SERVICE DIRECTIVE BULLETIN NO. T-062

Revision 2

1.    SUBJECT:    Drag Strut Assembly Inspection
2.    MODEL:        480 and 480B
3.    EFFECTIVITY:    S/N 5249 and prior
4.    BACKGROUND:

Figure 2. P/N 4174001-105 drag strut hardness test and marking

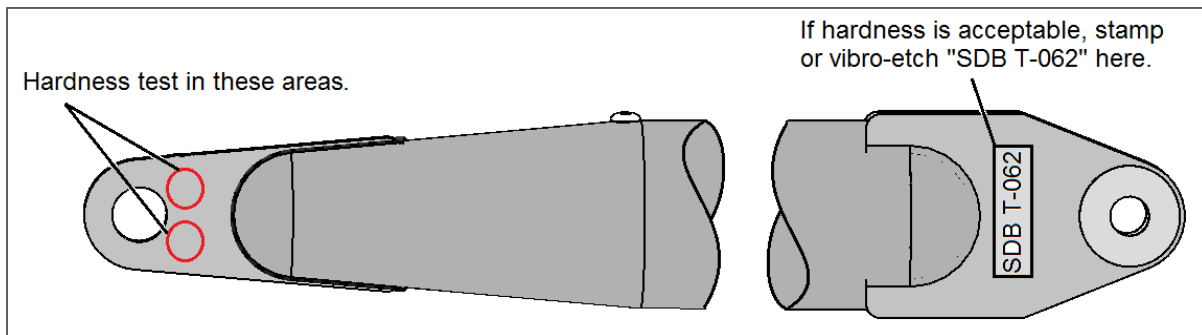
- 6.4.1 Remove the paint from both sides of the attachment plate.
- 6.4.2 Using a Rockwell Hardness Tester or equivalent, check the hardness of the attachment plate in either of the areas shown in Figure 2. Conduct hardness testing per ASTM E18.
- 6.4.3 If the hardness is 80 or higher on the Rockwell B scale, the attachment plate is acceptable. Refer to paragraph 13.2.
  - 6.4.3.1 Stamp or vibro-etch "SDB T-062" in the area shown in Figure 2. If marking only one side, install the strut such that the marking is visible upon installation.

- 6.4.3.2 Repaint the bare and the stamped or vibro-etched areas with MIL-PRF-23377 epoxy primer, or equivalent. At the operator's option, restore the black topcoat. Ensure that the "SDB T-062" is visible after applying the epoxy primer and/or topcoat.

- 6.4.4 If the hardness is less than 80 on the Rockwell B scale, continue the repetitive inspection procedures at 25 or 50 hour intervals or replace the 4174001-105 Strut Weldment with a 4174001-107 Strut Weldment.
